BCC DS
RECEIVED
12/11/2026
APPLICATION REF
A007150878

Minor Change to Development Approval at 44 O'Connell Street, Kangaroo Point (Council Ref.: A006599967)

Figure 2: *Proposed glass balustrade at lawn edge*

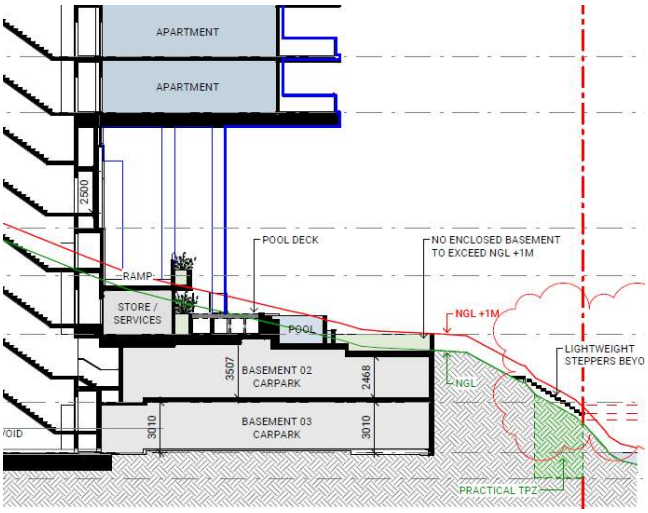
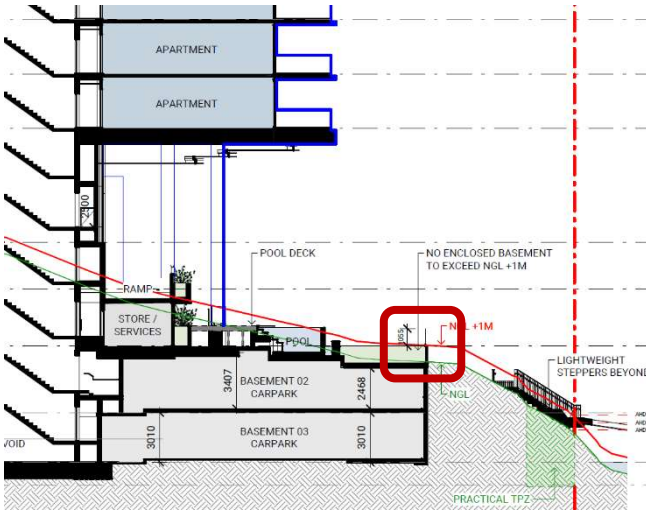
The proposed change includes a new glass balustrade at the eastern perimeter of the communal lawn within the riverside garden (i.e. the Basement 01 level). The balustrade responds to the site's steep fall toward the riverbank, providing an appropriate safety barrier while maintaining the functionality and amenity of the communal open space.

As illustrated in **Figure 2**, the height is approximately 1.055m. Its transparent glass construction will minimise visual impacts and preserves views toward the Brisbane River. The balustrade does not alter the approved function, layout or usability of the approved communal open space. Access to the steep riverbank was never intended from the lawn, with movement instead provided via the approved steps and pathway to the pontoon.

***Figure 3**: Proposed bedroom conversion on Level 13*

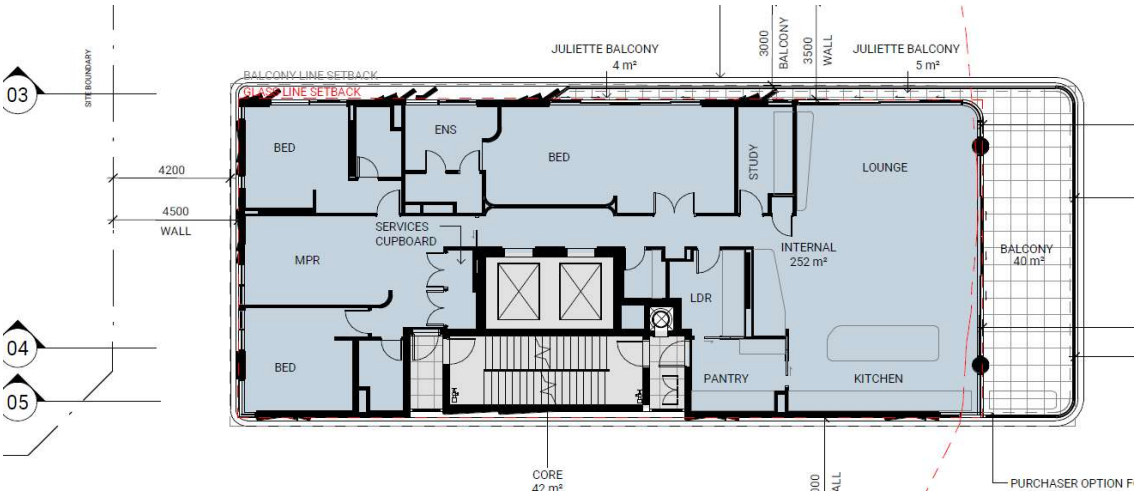
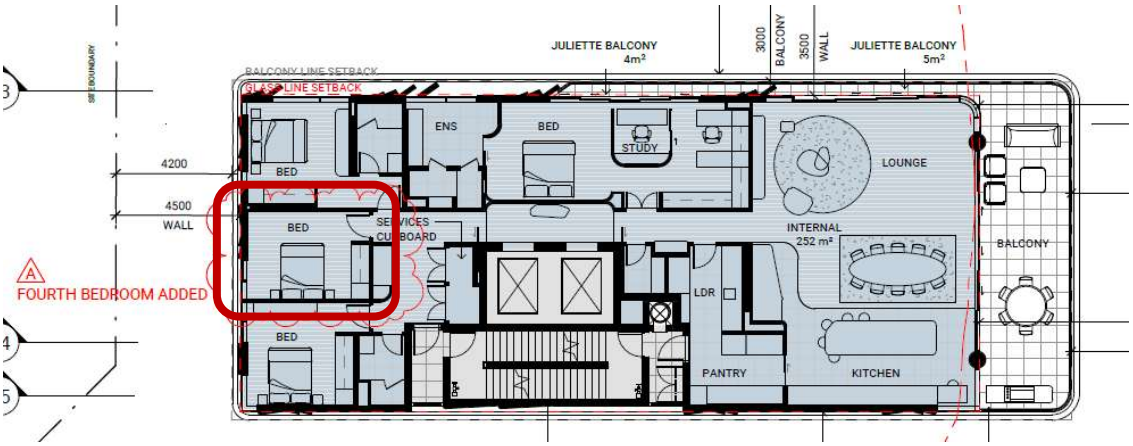
The proposed change seeks to enclose and convert a previously approved multi-purpose room on Level 13 into a new bedroom, making the unit into a 4-bedroom apartment.

Previously, Levels 2-14 were all approved with the same floor plan and internal layout, with three bedrooms and one multi-purpose room (MPR). In response to market demand, the MPR on Level 13 is now proposed to be converted into a fourth bedroom, expanding the overall dwelling mix. The proposed change is illustrated below in **Figure 3**. As a result of this change, Level 13 now has a different floor plan to Levels 2-12 and 14 (therefore requiring updates to the approved plans and drawings, see **Section 4.1** below).

***Figure 4**: Proposed internal floor plan changes to Level 15 (lower penthouse)*

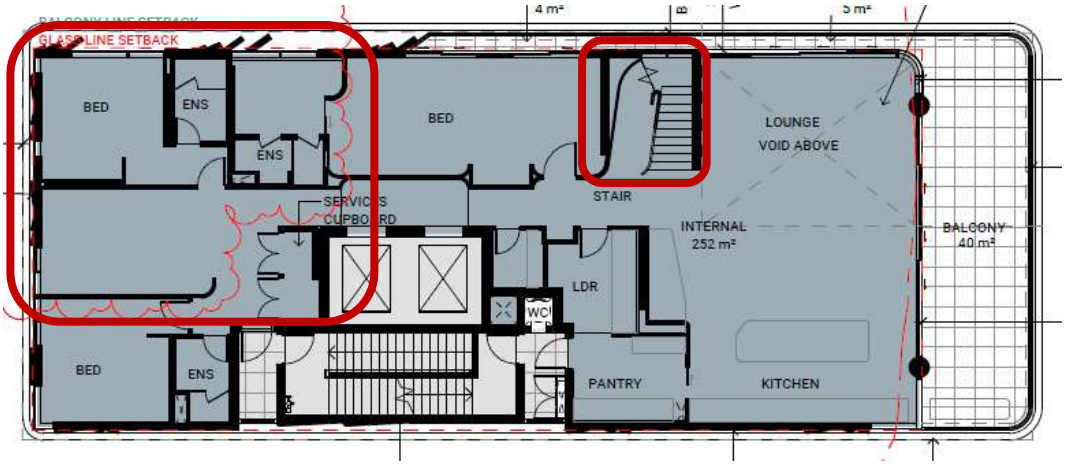
At the lower penthouse level (Level 15), the changes are entirely internal. The north-western bedroom and ensuites are proposed to be reconfigured to enable the creation of a new MPR, effectively matching the layouts on Level 2-12 & 14. The proposed staircase arrangement is also proposed to be changed, now ascending in an anticlockwise manner. These changes are illustrated below in **Figure 4**.

***Figure 5**: Proposed internal floor plan changes to Level 16 (upper penthouse)*

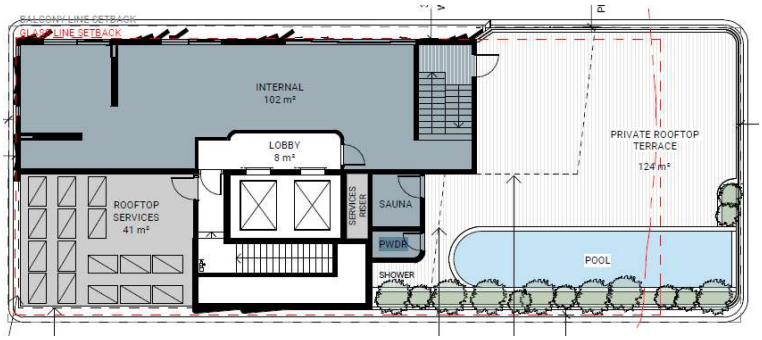
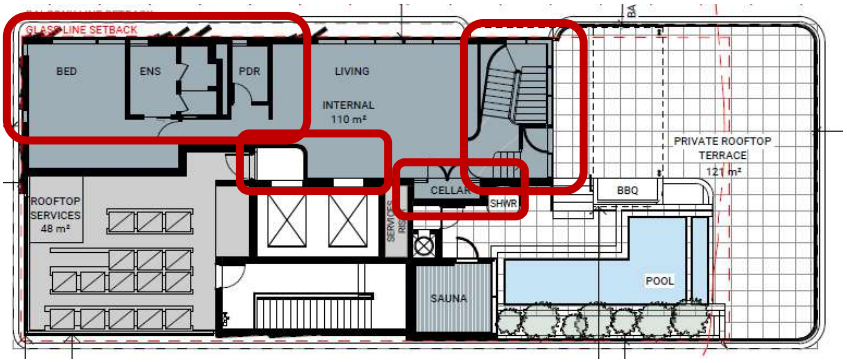
At the upper penthouse level (Level 16 – see **Figure 5** below), the internal areas have been reconfigured to better support circulation and accommodate a new bedroom with ensuite bathroom, storage space, and cellar. The proposed staircase arrangement is also updated, per the changes to the lower penthouse level. The extent of the staircase roofing has also been adjusted in turn (see **Figure 7** below). The only other internal change at this level is the reduction of the lift lobby area, which has been reconfigured to provide access to rooftop services only, removing the secondary penthouse access approved previously.

Figure 8 *Proposed mechanical screening changes*

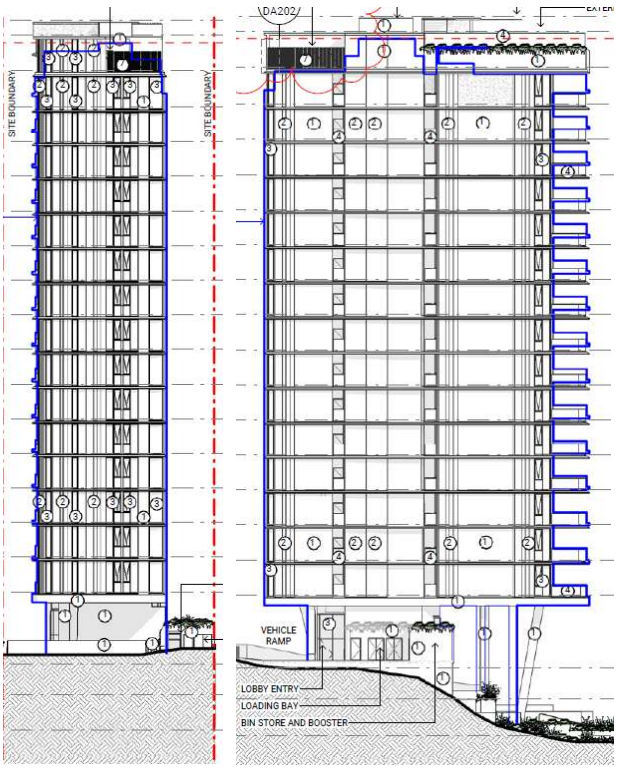
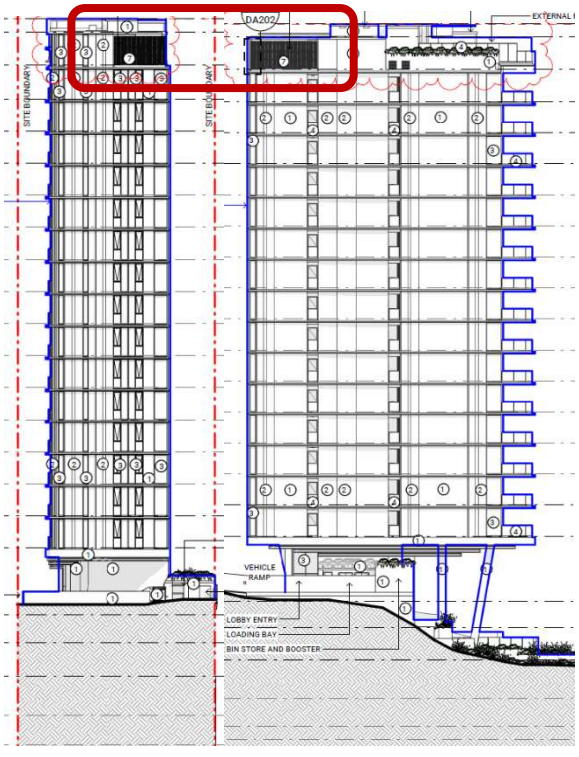
The proposed change also includes a minor increase in the height of the approved rooftop mechanical screening by approximately 1.0m. The added height is required to ensure that the rooftop plant and equipment remain appropriately screened from surrounding viewpoints.

The proposed aluminium batten screen will be 2.95m tall, ensuring a minimum 1m clearance above the height of adjacent mechanical equipment. It will be located along both edges of the mechanical plant area in the south-western corner of the building rooftop. Plans providing added technical detail have been incorporated within the architectural package (please refer to the proposed updates to approved plans and drawings in **Section 4.1** below).

The additional height is limited to the screening structure only and does not exceed the existing building height. It serves a purely functional purpose by improving the visual screening of rooftop services and maintaining the high-quality architectural presentation of the building. The resulting changes to the building elevations are minor, as captured below in **Figure 8**.
